PIC16F62X Rev. A Silicon/Data Sheet Errata

The PIC16F62X (Rev. A) parts you have received conform functionally to the Device Data Sheet (DS40300C), except for the anomalies described below.

PIC16F62X

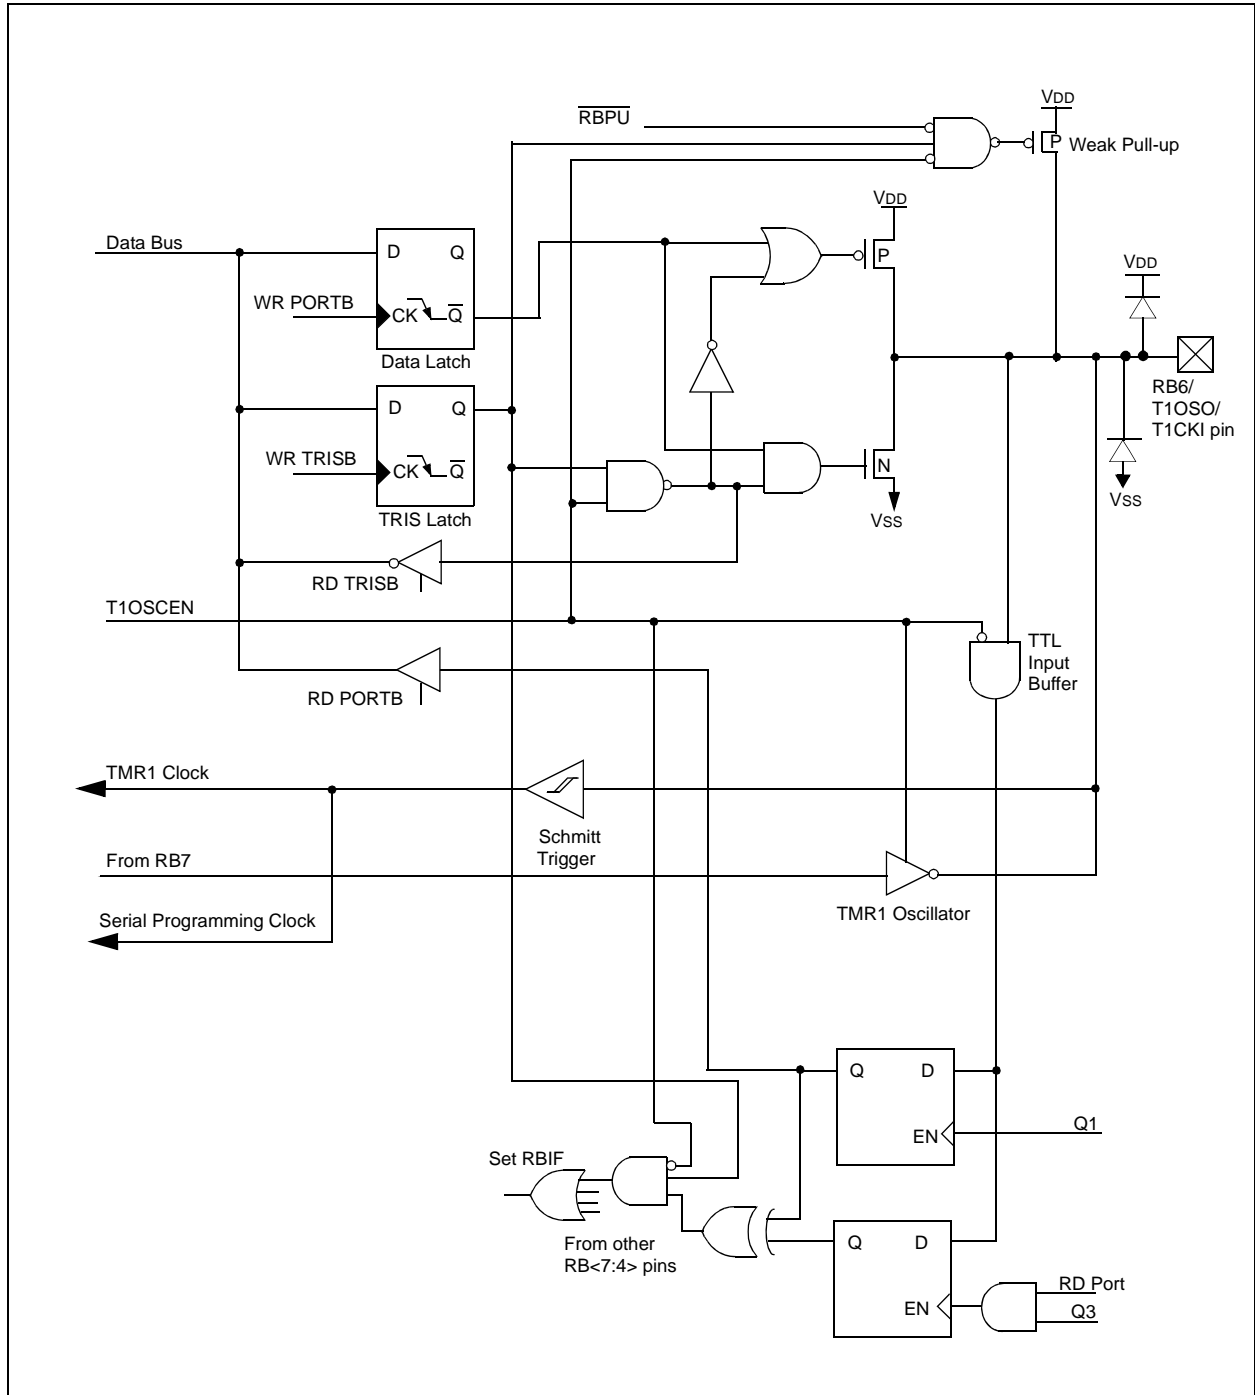
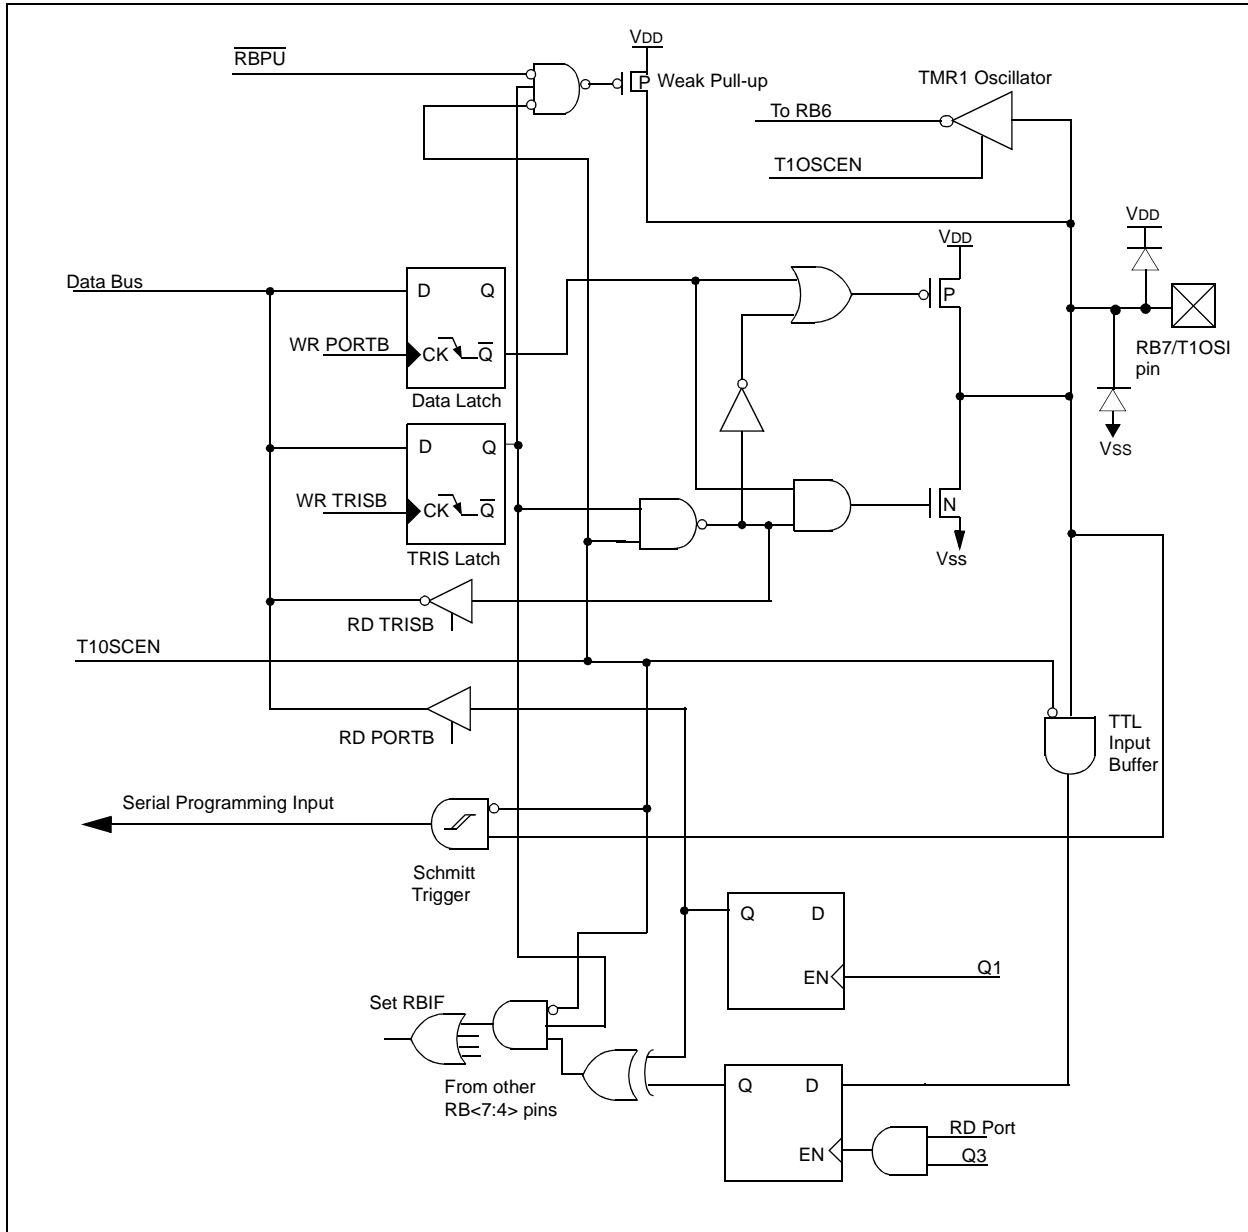
1. Module: I/O Ports

A read of the PORTB Data Direction Register (TRISB) returns the Data Direction state on the port pins themselves and not the contents of the TRISB register latch.

FIGURE 5-5: BLOCK DIAGRAM OF THE RA5/ $\overline{\text{MCLR}}$ /VPP PIN

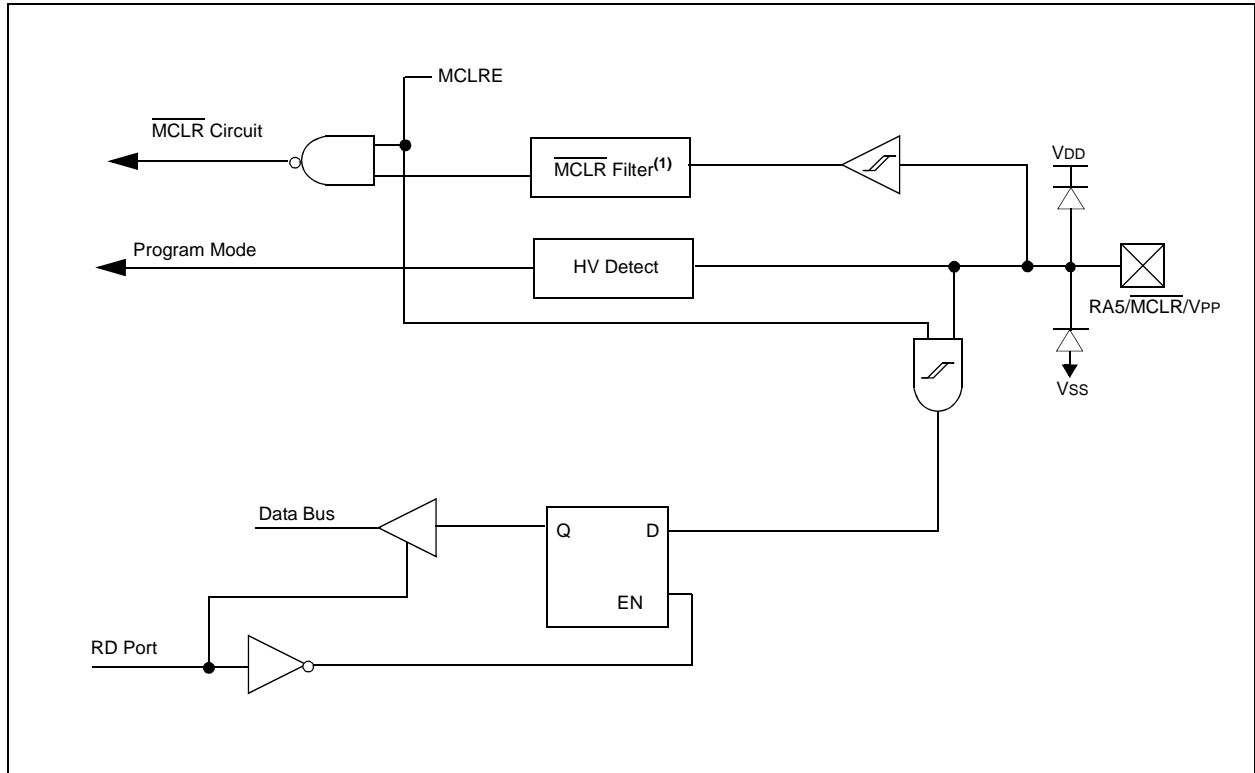
3. Module: I/O Ports (RA5/ $\overline{\text{MCLR}}$ /VPP)

Figure 5-5, "Block Diagram of the RA5/ $\overline{\text{MCLR}}$ /VPP Pin", is incorrect. The following diagram should be used instead.
